NLI-QA-3595
Date 5/22/2017

SUBJECT: RESPONSE TO TWO NOTICES OF NONCONFORMANCE CONTAINED IN NUCLEAR REGULATORY
COMMISSION INSPECTION REPORT 99901471/2016-201

Figure 1 below illustrates the timing of the trip unit and breaker.

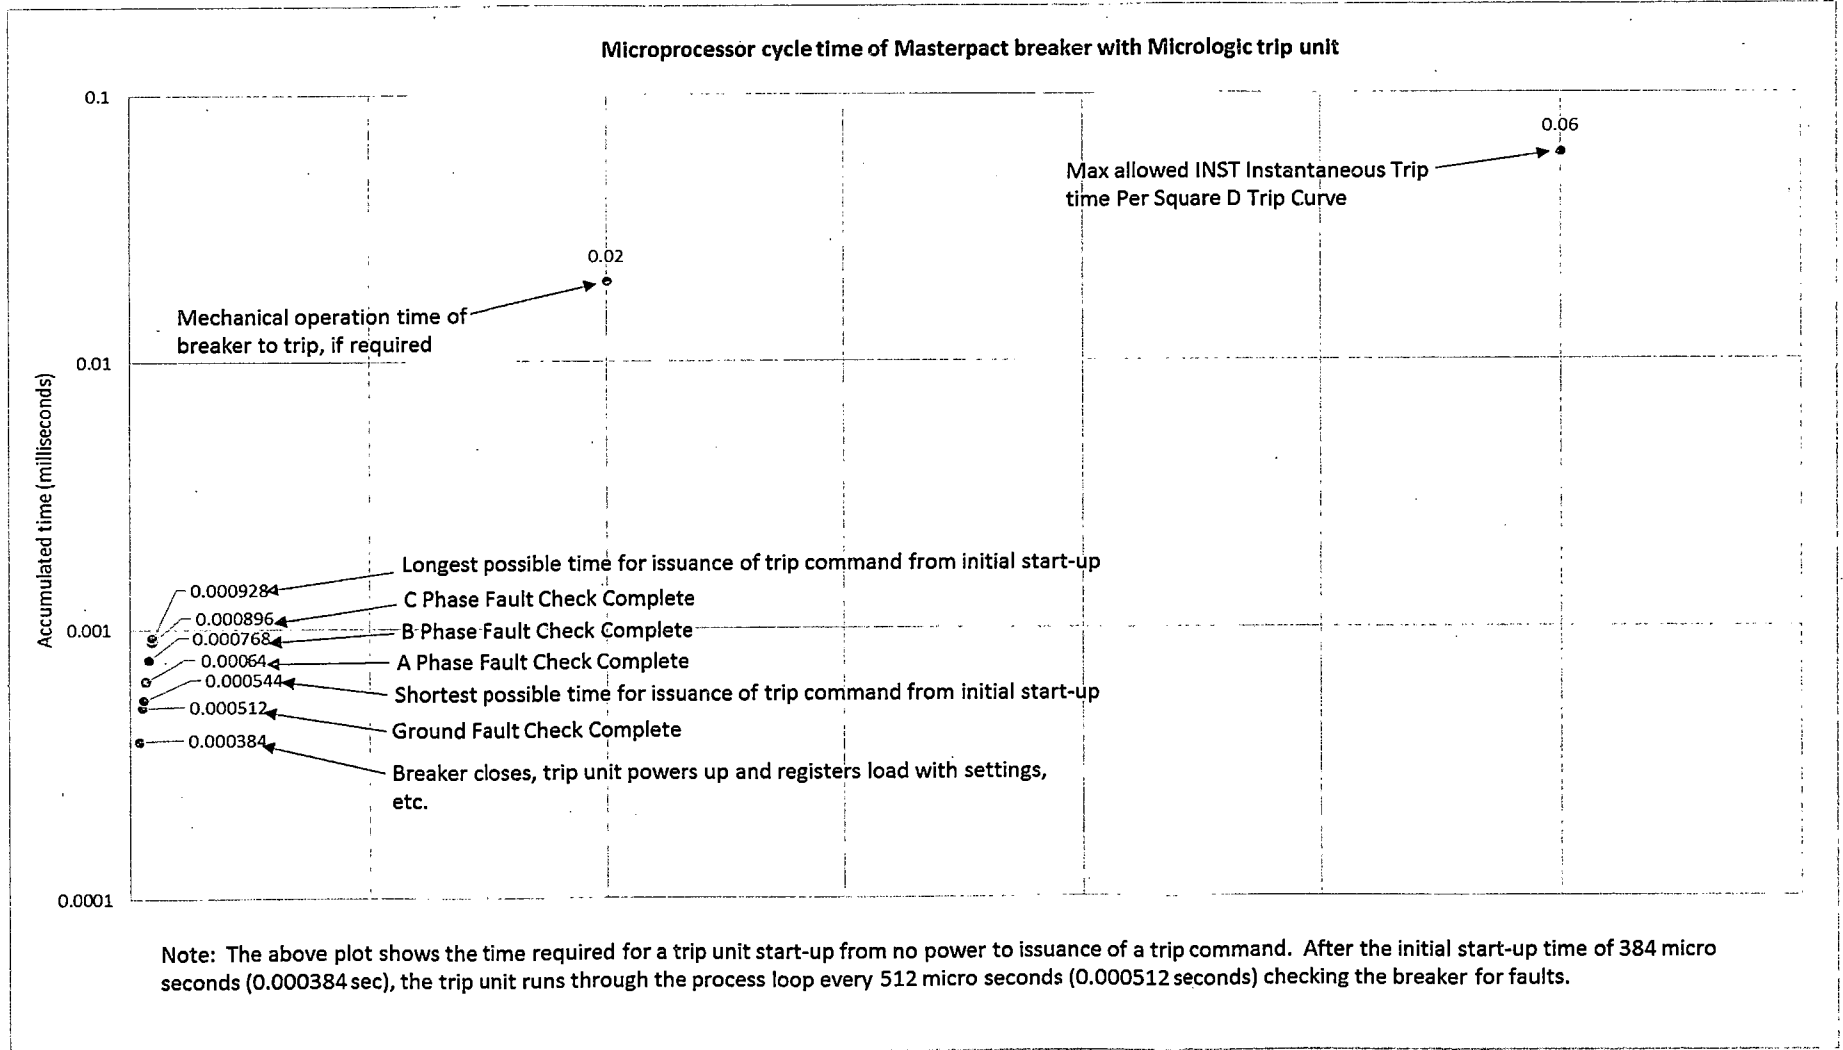
In the NRC response letter dated 4/10/2017, it is stated that NLI has not performed an analysis of the acceptability of the overcurrent trip circuitry when used in this application. However, NLI had evaluated the trip unit circuitry in detail and the timing of the circuit process was documented in the original report that was issued May 7, 2004. The timing of the circuit is documented in VVR-042181-1;

Based on the process cycle time of 544 micro-seconds, the assumption that the trip unit receives an erroneous signal and is processing the data incorrectly is not viable. After the first cycle time of 928 microseconds [0.000928 seconds] ($0.000384 + (0.000128 \times 4) + 0.000032$), the trip unit repeats the process loop every 544 micro-seconds. The nuisance trip times reported by PSEG were in the range of approximately 0.5 to 4 seconds. Therefore, if the trip unit tripped the breaker in 0.5 seconds then the process loop would have been repeated approximately 920 times, which would indicate that the trip unit was operating properly after the initial startup.

After the trip command is issued, the mechanical operation of the breaker to move from the closed to the fully open position is approximately 20 milliseconds. From the issuance of a signal to trip, the total time for tripping the breaker is less than 25 milliseconds. Based on the information provided above regarding the start-up time of the trip unit, if the trip was caused by the processor being confused, the nuisance trip would have occurred within the first 25 milliseconds of operation. Due to the fact that the trips were anywhere from 0.5 to 4 seconds (as reported by PSEG) it is concluded that the trips were not as a result of the startup time of the trip unit.
